Supplemental Design Investigation Sampling Plan - Revision 1

Northern Impoundment San Jacinto River Waste Pits Superfund Site

International Paper Company and McGinnes Industrial Maintenance Corporation

Response to Comments – Supplemental Design Investigation Northern Impoundment San Jacinto River Waste Pits Site Harris County, Texas

FIGURE 3

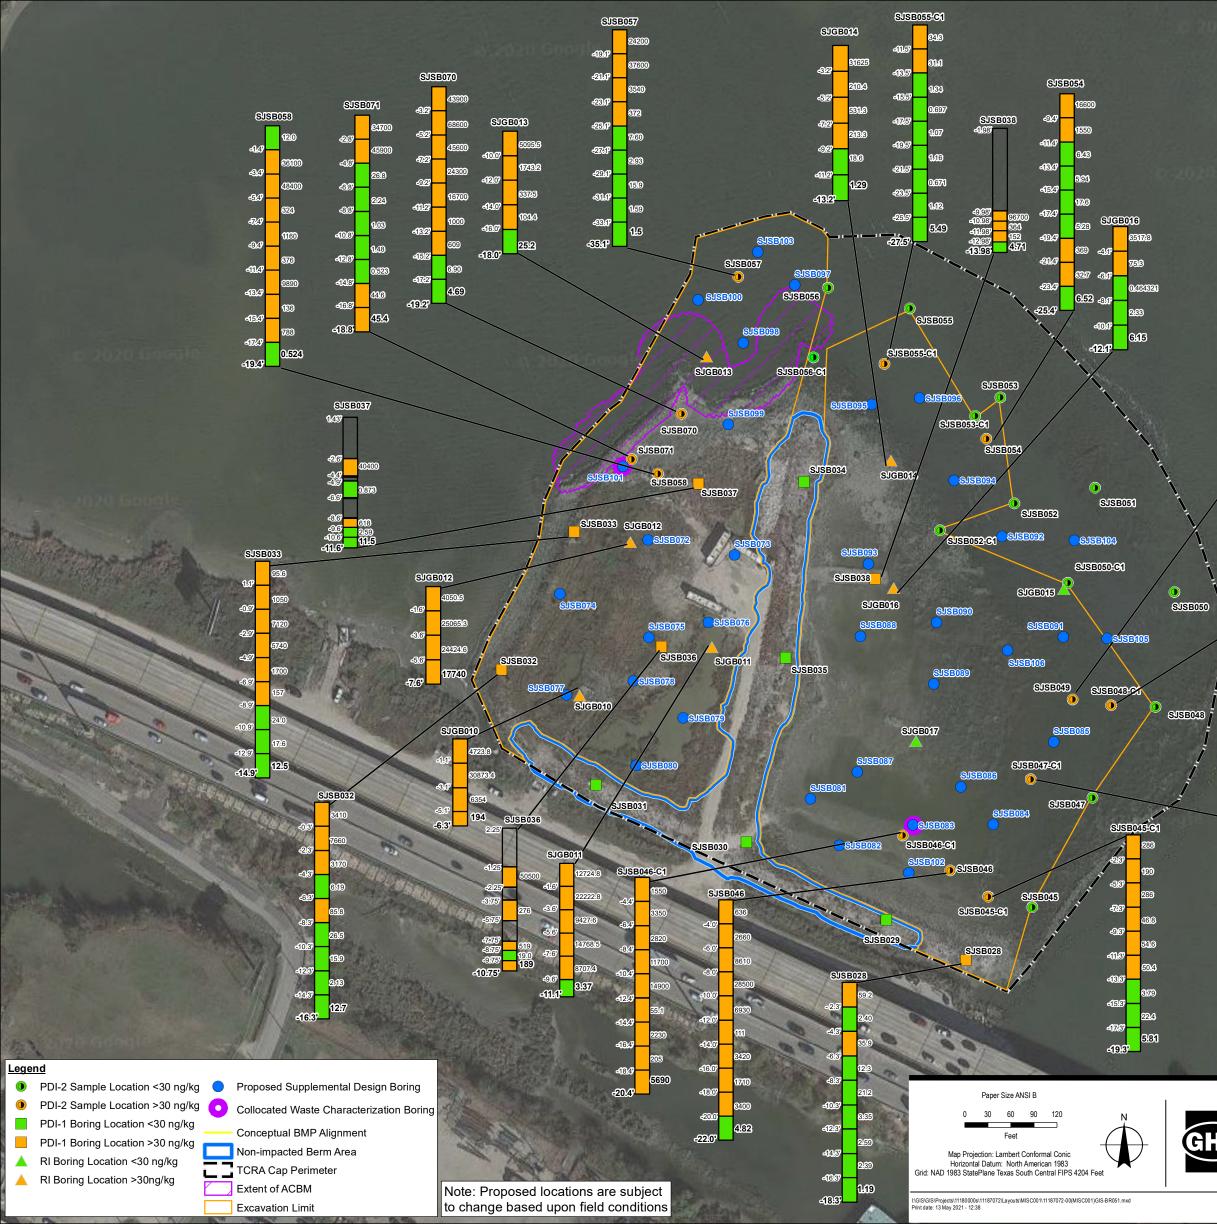
Geotechnic	al Samples Comments fro	m the EPA	
1	Figure 3	Update Figure 3 to include locations of geotechnical samples that were taken during previous investigations.	Figure 3 has been updated to include previous geotechnical sar second phases of the PDI.
